BROOKHAVEN NATIONAL LABORATORY  
ASSOCIATED UNIVERSITIES, INC.

November 30, 1979

RE: Evaluation of NUTECH's In Situ Test Method - NUTECH report SSP-01-001,  
October 3, 1979 "Smoke Simulation Prototype Test Conducted at Yankee Rowe  
Nuclear Plant."

Figure 1. Detector sensitivity versus particle size for a light-scattering type detector (S-2) and for an ionization type detector (R-2) [15].

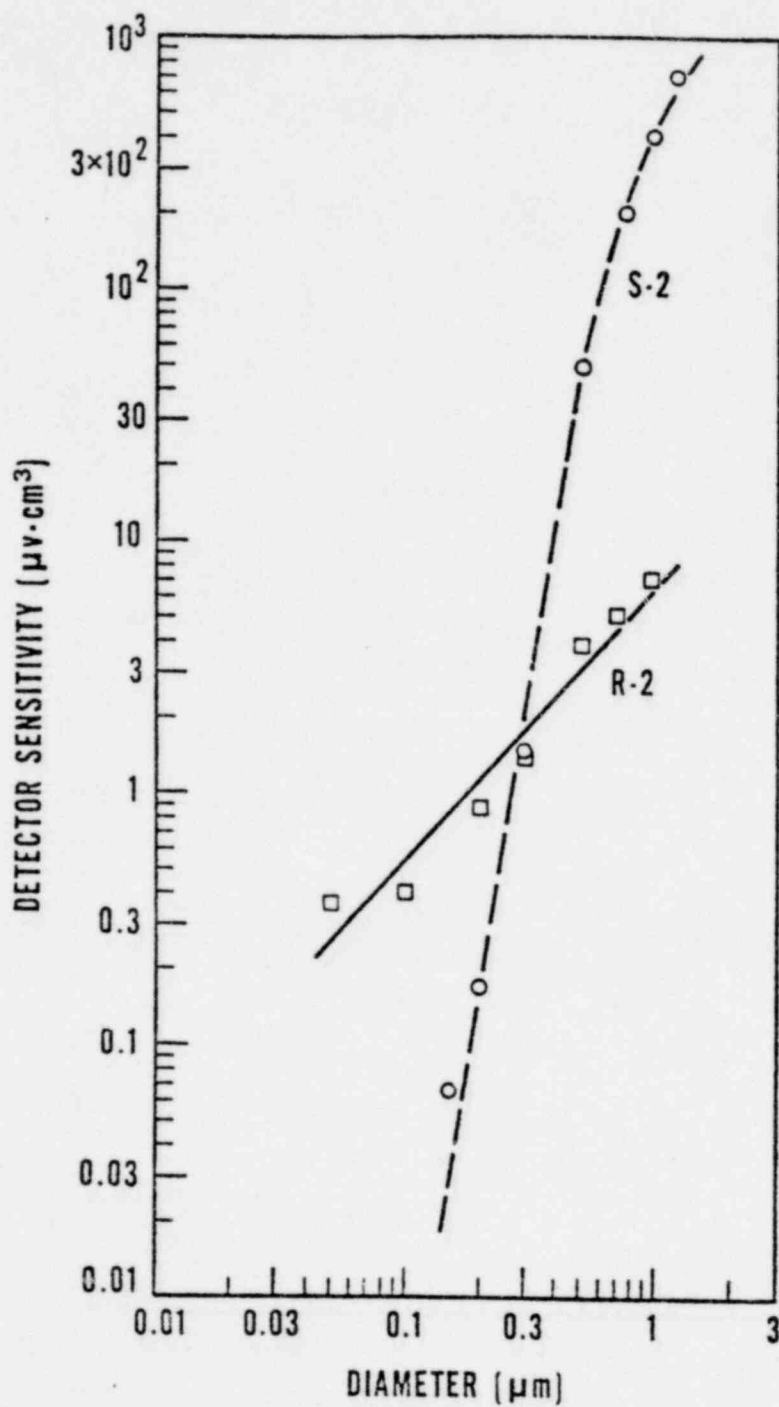
Research on the effects of particle size and size distribution on smoke detector sensitivity is continuing at NBS in conjunction with the excellent capabilities at the University of Minnesota for the measurement and generation of aerosols. Figures 1, 2, and 3 taken directly from Bukowski and Mulholland's report on smoke detectors show to some extent the effects of particle size on detector sensitivity (Figure 1) and size distribution as a function of material burned (Figures 2 and 3). From Figure 1 the ionization

detector can be correlated with particle diameter using a linear fit to a log-log plot. This indicates a power law relationship between detector sensitivity and particle size with the empirical relationship being (given by Bukowski and Mulholland)

$$S = 6.7 \bar{D}_g^{1.1}$$

Figure 2. Optical density per meter versus mass concentration for lamp wick smoke and heptane smoke [20].

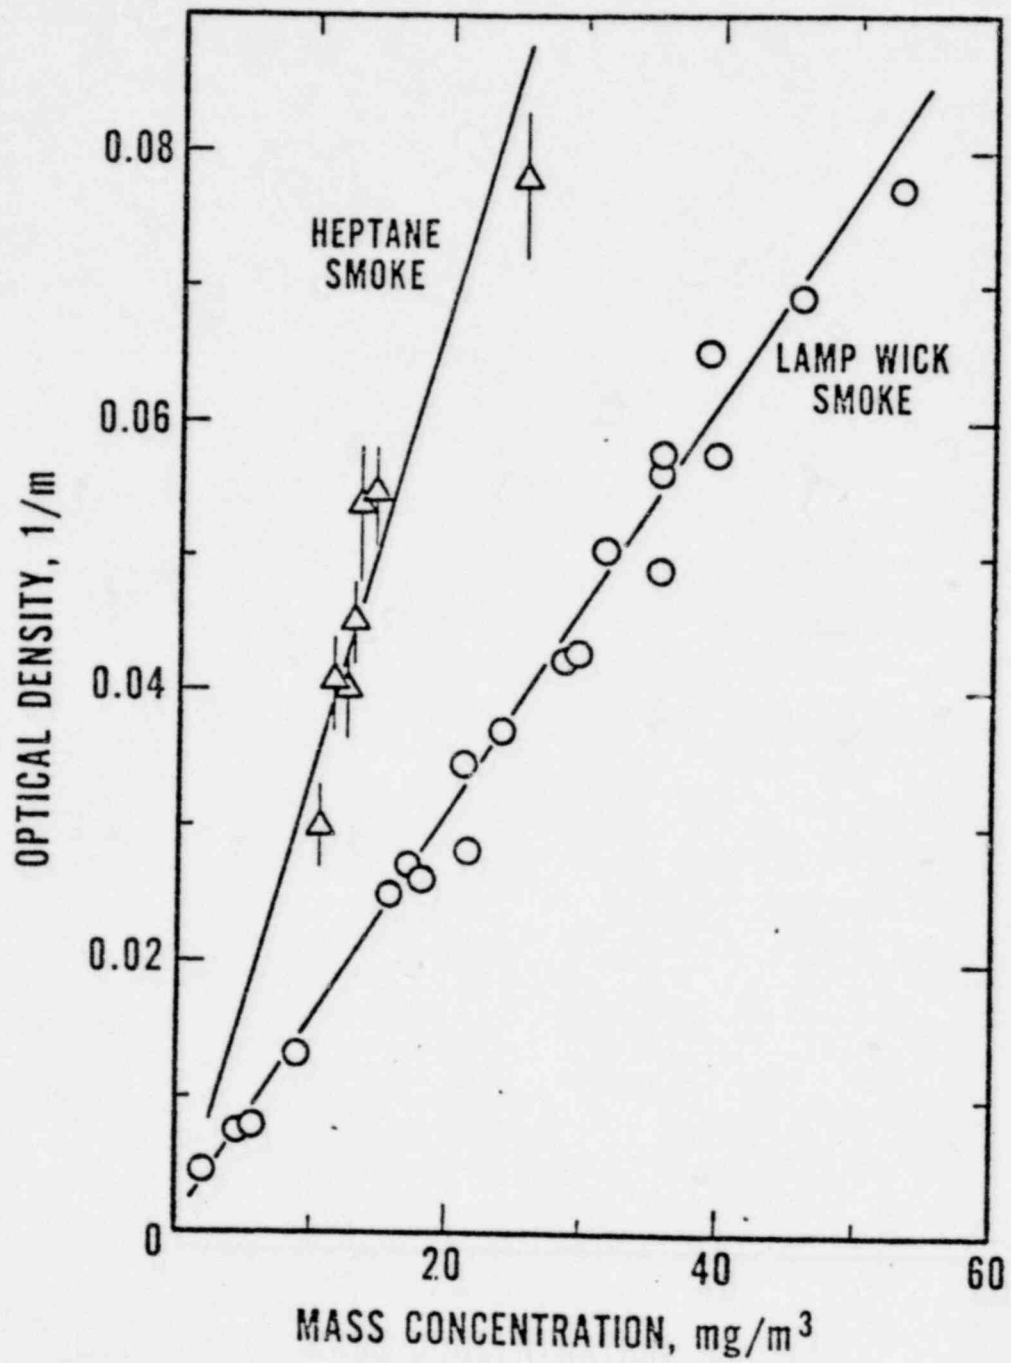
where N represents the total number of particles and n represents the number of size classes. Figures 2 and 3 indicate that the geometric mean diameter is a function of the material burned and how it is consumed. The tracer gas test methodology cannot differentiate these effects, i.e., it cannot simulate the particle size and its distribution normally ascribed to smoldering and/or flaming forms of combustion.

Figure 5. SF<sub>6</sub> Plots at grid C2 for Test 2, 3, 5, 6.

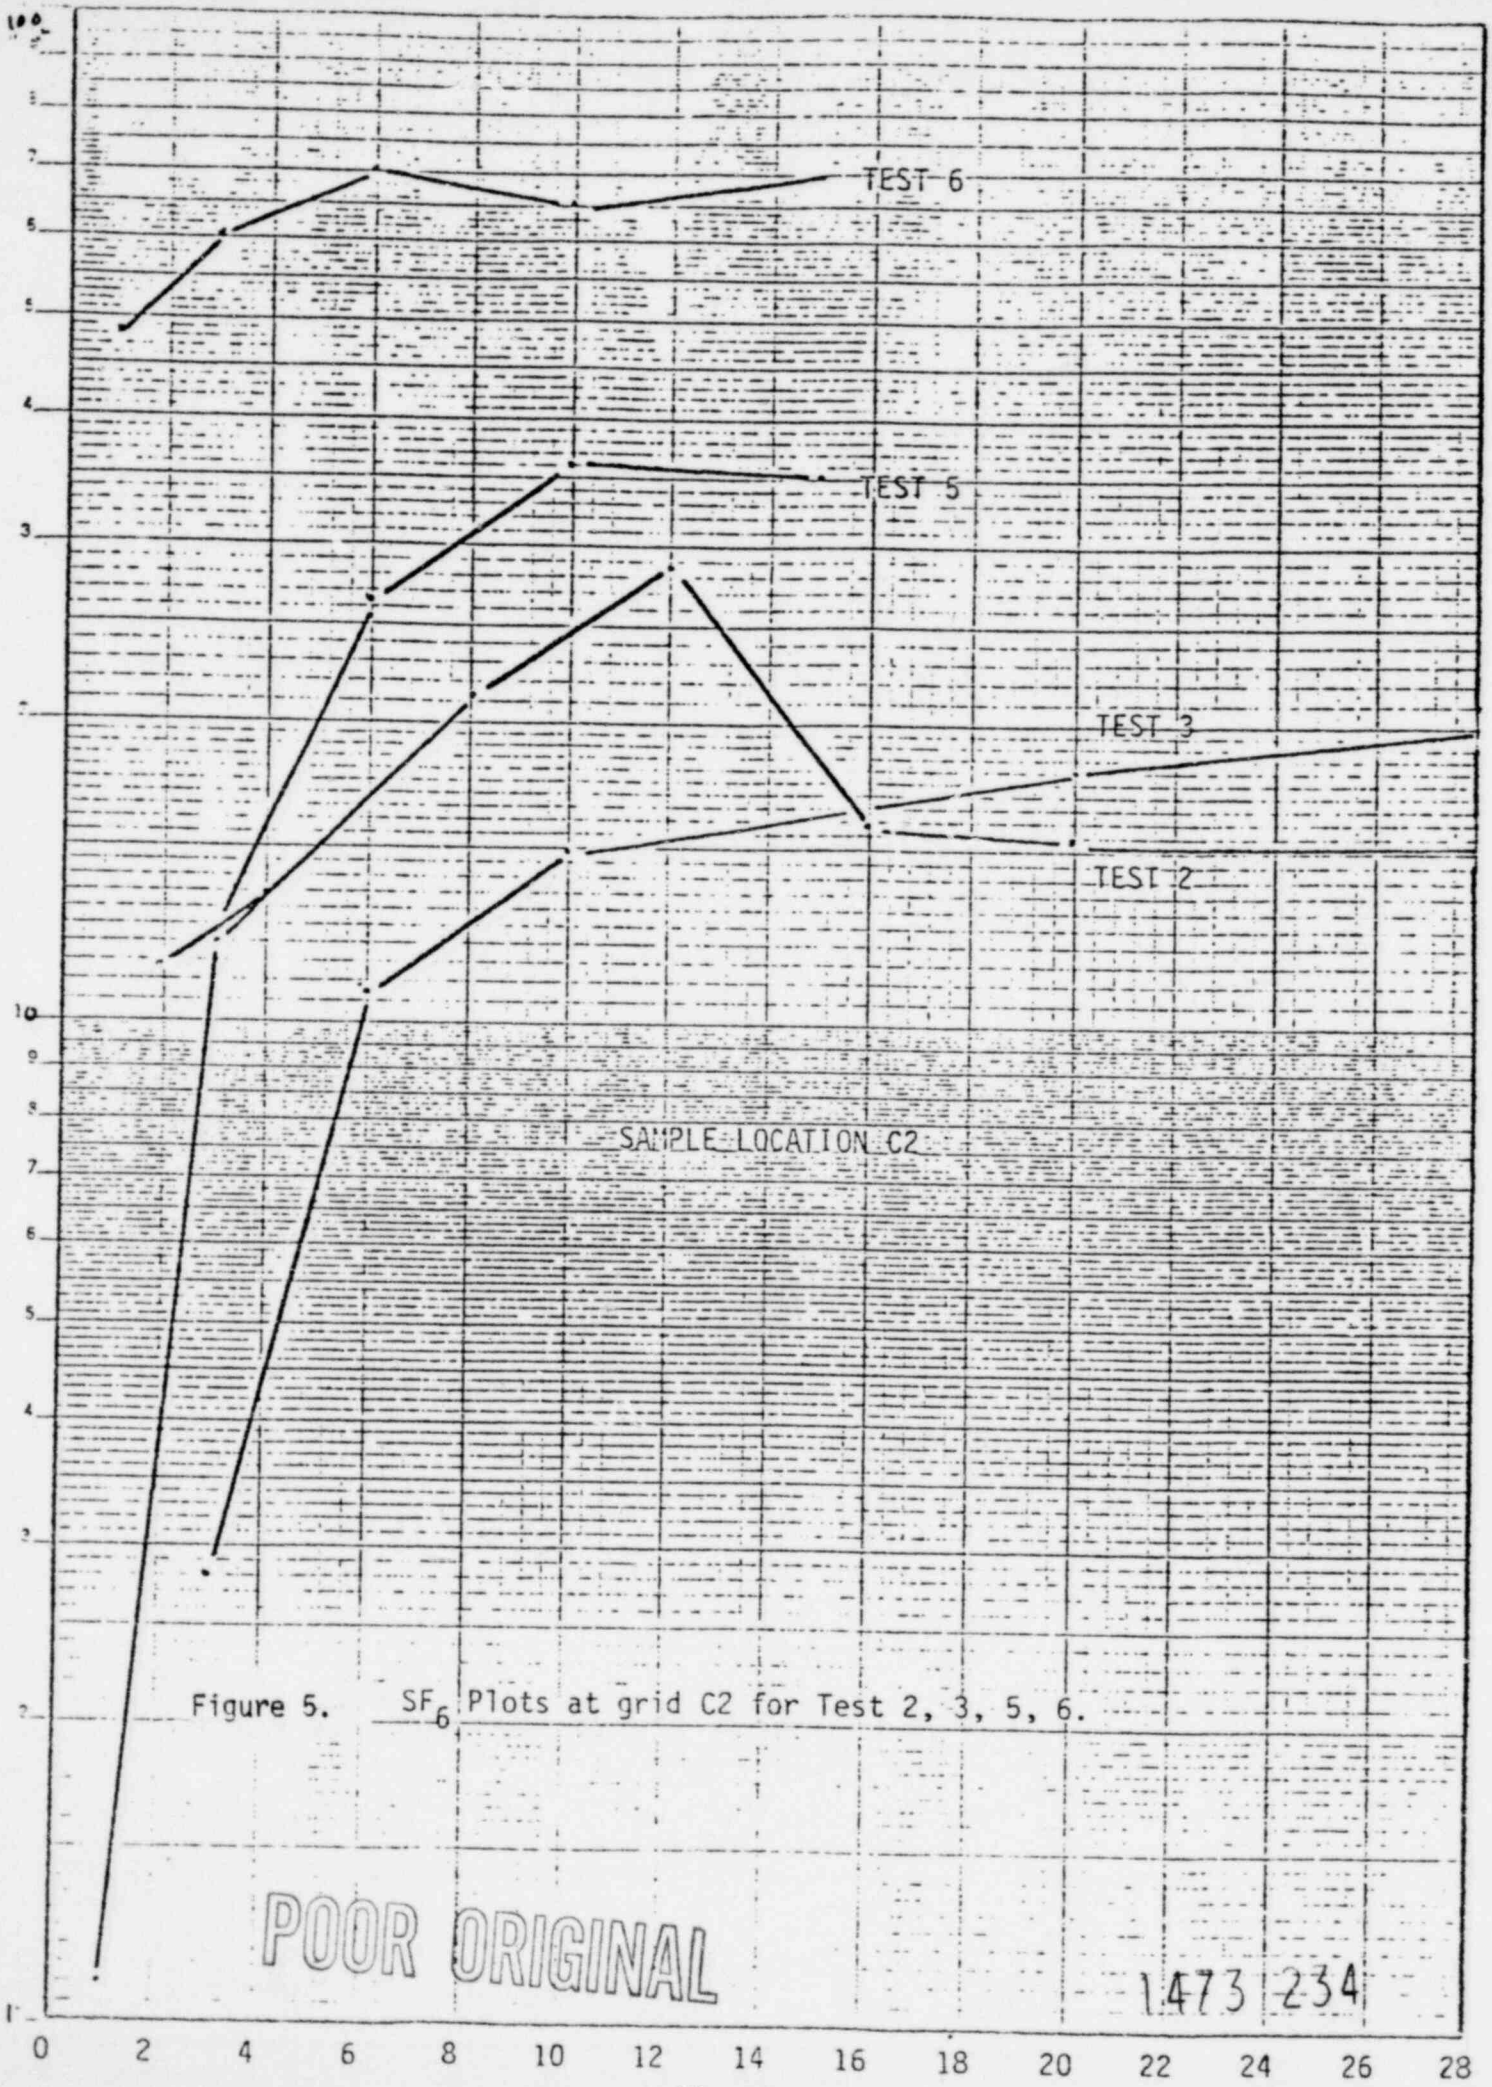
the table on page D-2 should be (66, 45), (75, 100), (87, 91), (91, 46), (65, 50). This test indicated that the lefthand corner of the room is a relatively stagnant region; visual observations confirm this as well. However, the relatively low readings in location C2 and C3 have been attributed to the dilution effect due to the high air flow on top of the two battery rooms which are located within the area. This may or may not be true since the exhaust system operates as a flow sink and concentrations can be high in this region. I have plotted the data recorded at sample location C2 for Test 2, 3, 5, 6 (Figure 5 attached), which generally shows higher values for fire locations further away than that for Test 2. Examining this figure the question that naturally then arises is if dilution causes the lower readings for Test 2, then why not lower readings for the other tests where there may be additional dilution due to natural excursion of the tracer gas from one end of the room to the other. A possible re-interpretation of this particular test, using global effects from the other tests as well, can be that the tracer gas movement with the source located in the lefthand portion of the room is strongly affected by the positive pressure gradient across the battery room doors. That is low readings at station C2 and C3 for this test are not caused by the dilution effect of the exhaust port located on top of the battery room but possibly because a large fraction of the tracer gas had been injected into the battery rooms. Note also that readings at sample location B21, which were taken at chest height are in some instances larger than the ceiling values taken at the same grid point. And also, the higher readings on top of the battery room for test performed with the simulated fires at the righthand portion of the room is because the tracer gas was more apt to be affected first by the HVAC system located near the ceiling.

Finally, the normalization procedure that is used in presenting the raw data complicates test by test comparison. Another factor which has made time-wise comparison of a given test difficult is the unsteady behavior of the SF<sub>6</sub> source (a factor which must be corrected if tests such as this are to continue) since one cannot now ascribe tracer gas buildup in a given area due to possible re-entrainment of SF<sub>6</sub> as a result of the circulatory flow patterns within the room on due to the unsteady character of the source. In addition, determining those locations which first sense the tracer gas is only part of the overall problem in smoke detector site location since there is a complex inter-relationship between the physical properties of real smoke, viz, particle density, size distribution, aging, and mass concentration and the alarm threshold of smoke detectors. However, as the state-of-the-art now stands, if tests, like NUTECH's, show areas in the test room where tracer gas concentration increases rapidly, tends to stabilize, and then rises again, while contiguous areas are relatively stable by comparison, then one can ascribe this trend to either the global circulation pattern within the test area as the possibility for this re-entrainment process or due to localized turbulent eddy behavior and not because of unsteadiness in the source. Placement of smoke detectors in areas having the aforementioned SF<sub>6</sub> concentration trends, together with the effects of smoke on detector threshold response as are currently being investigated at NBS, will lend more credance to the necessary valued judgements in detector citing.

- Repeat test 2 or 4 with samples stations concentrated in the lefthand portion of the room; check for repeatability.
- Take readings within the battery room near the door.

- Measure SF<sub>6</sub> concentration directly above source (approximately 3 feet above source) and use these data for reference.
- Provide assurances that SF<sub>6</sub> source is constant as well as heater output.
